SUBJECT: R. E. GINNA NUCLEAR POWER PLANT - AMENDMENT RE: CONTROL  
ROOM EMERGENCY AIR TREATMENT SYSTEM ACTUATION  
INSTRUMENTATION CHANGE (TAC NO. MB1887)

AMENDMENT NO. 83 TO FACILITY OPERATING LICENSE NO. DPR-18 GINNA NUCLEAR  
POWER PLANT

SAFETY EVALUATION BY THE OFFICE OF NUCLEAR REACTOR REGULATION  
RELATED TO AMENDMENT NO. 83 TO FACILITY OPERATING LICENSE NO. DPR-18  
ROCHESTER GAS AND ELECTRIC CORPORATION  
R. E. GINNA NUCLEAR POWER PLANT  
DOCKET NO. 50-244

**Figure 1. Radiation Monitoring System**

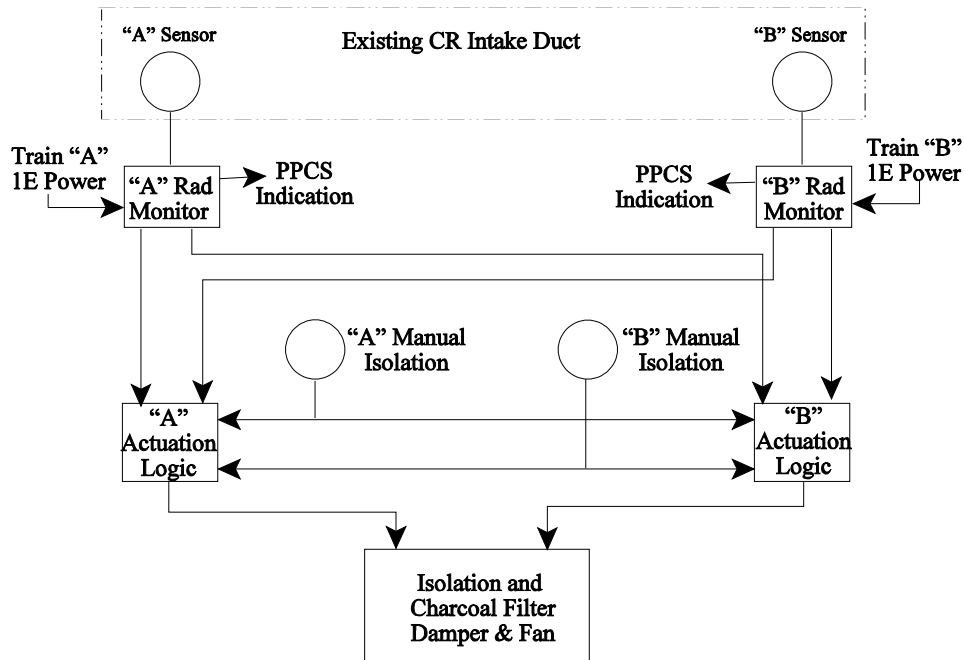
RG&E decided to replace the existing monitoring system with a pair of GM tube plenum probes, which would detect and measure the radiation within the 42-inch control room ventilation system air intake. The probes and associated monitors would be powered by two separate safety-related sources and would be configured into two redundant actuation logic trains, each with manual initiation. This style of monitor does not depend on a sample pump or any moving parts to accomplish its monitoring function, thereby providing increased system reliability (see Figure 1).

Figure 2. System Block Diagram

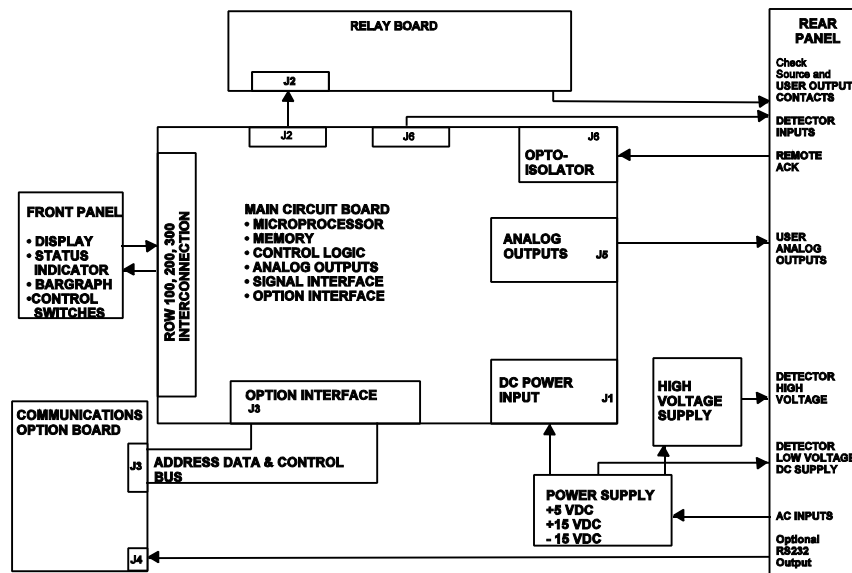
The Model 956A-201 UDR is composed of the following five circuit board assemblies mounted within the unit (see Figure 2):

Figure 3. Front Panel Display

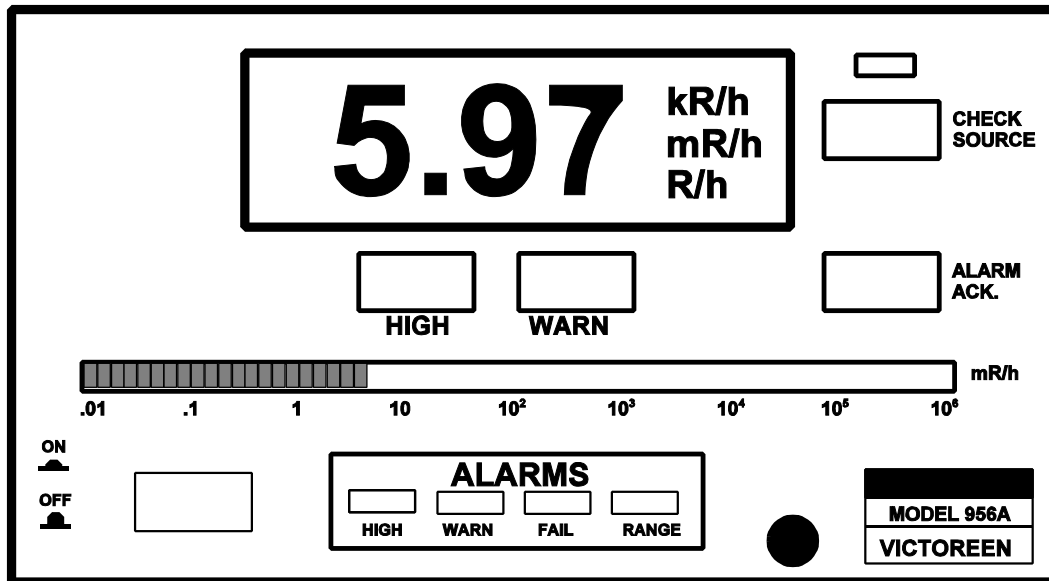
The front panel circuit board consists of the seven-segment display, backlights, status indicators, switches, and bargraph assembly (see Figure 3). The front panel interfaces to the main circuit board.
